Northwestern Water and Sewer District
2025 NWSD 100 Area Waterline Improvements
WL-100E

ADDENDUM 1

November 26, 2024

ODOT FENCE DETAIL
NORTHWESTERN WATER & SEWER DISTRICT, OHIO
2025 NWS 100 AREA WATERLINE IMPROVEMENTS WL-100E

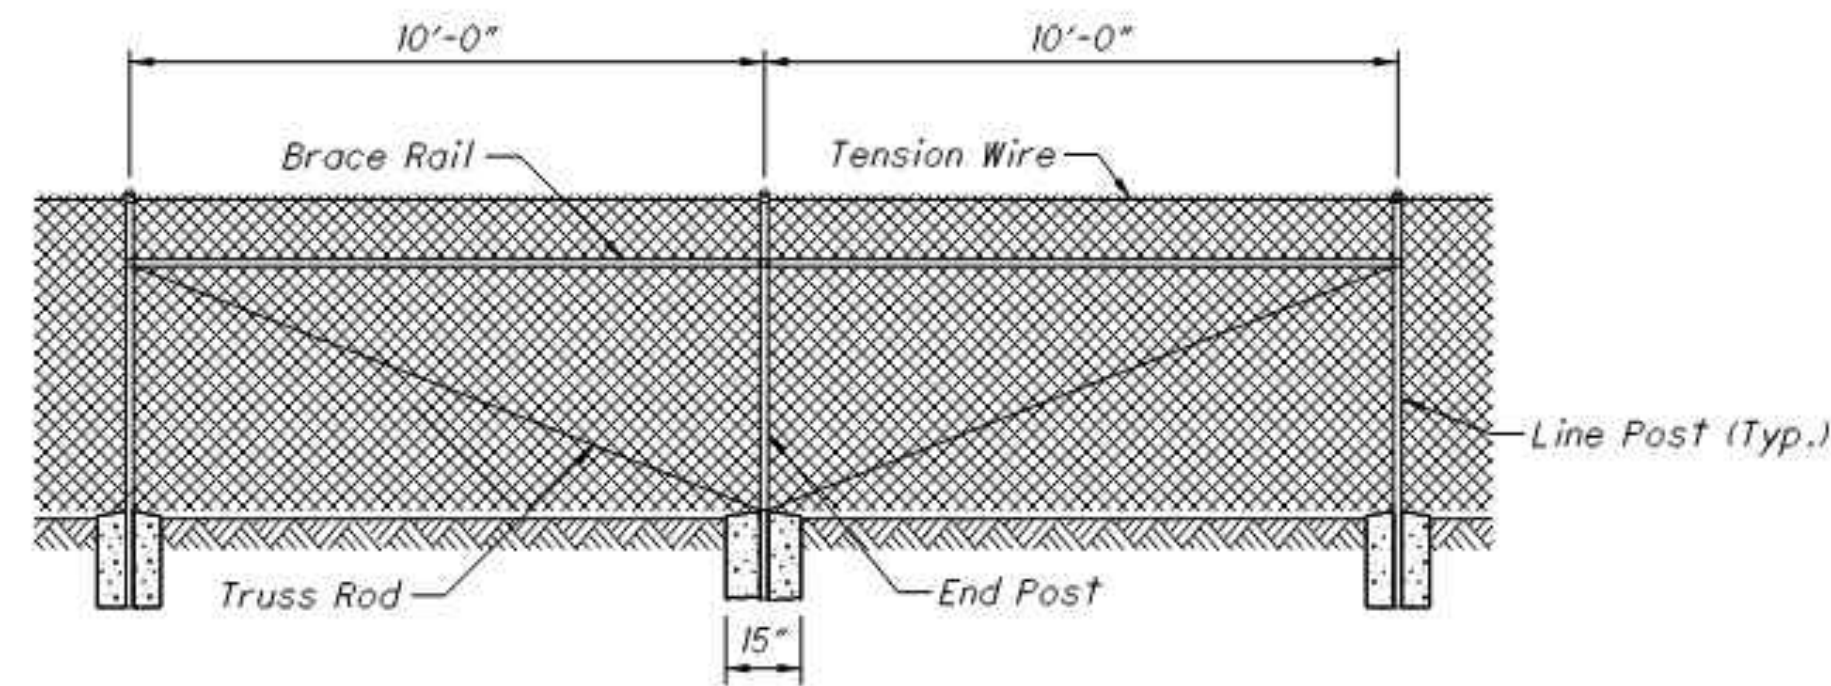
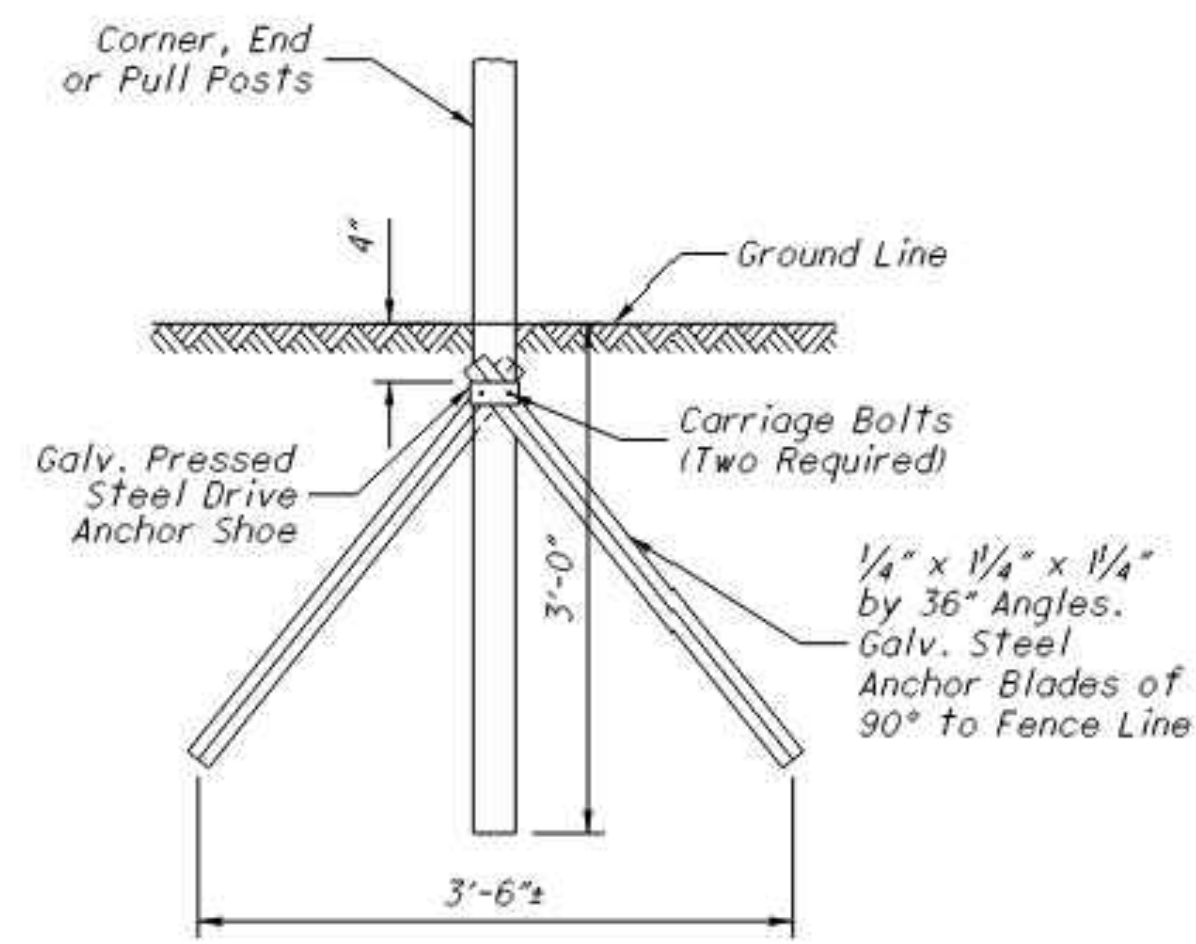
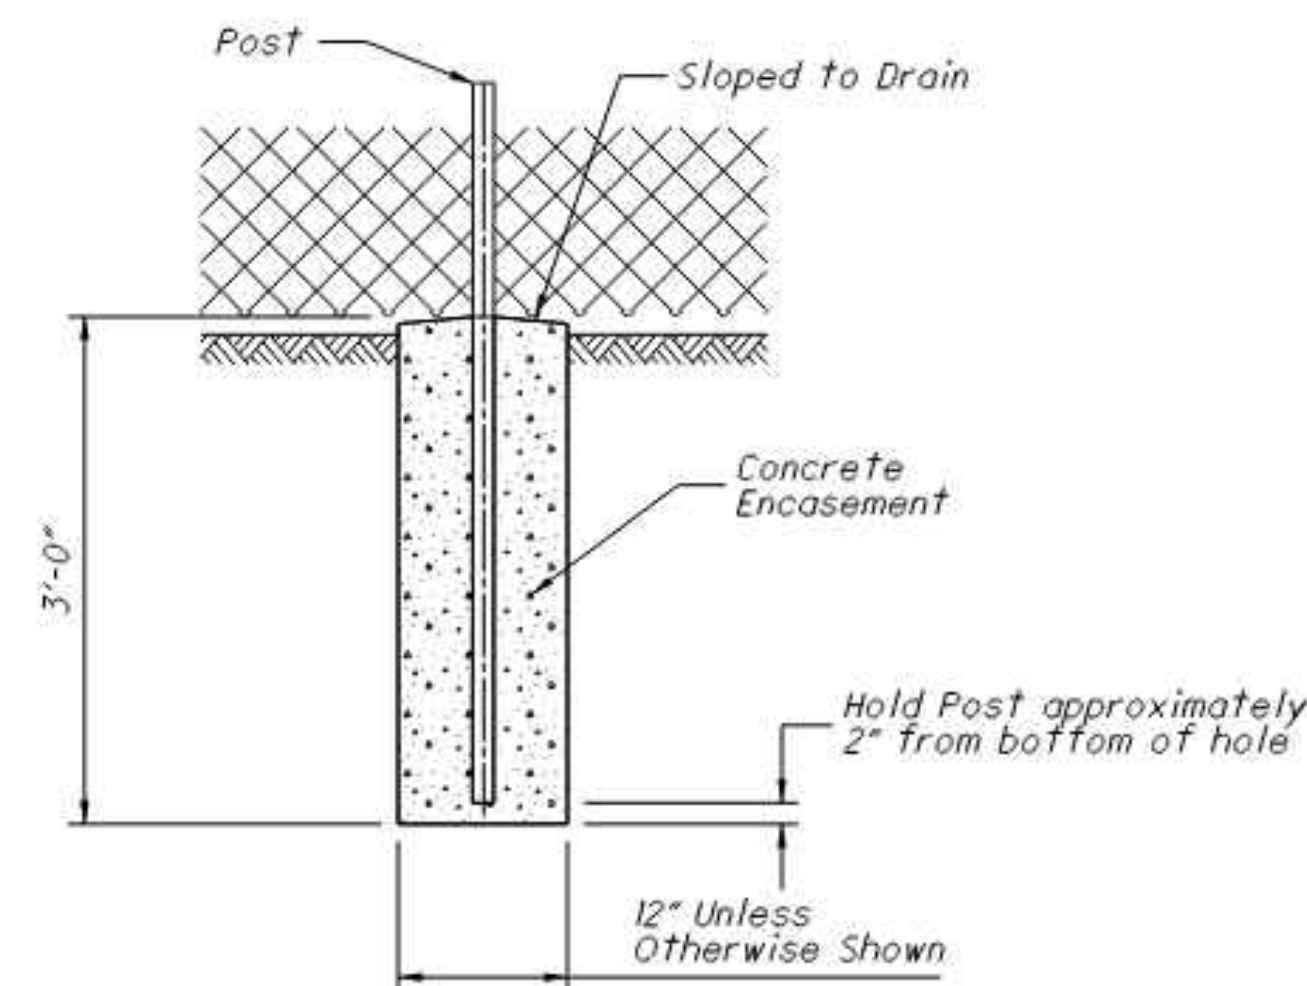
Replace Sheet G-0.1 and SR-0.5 with the attached sheets that add ODOT's fence detail to the drawing set.
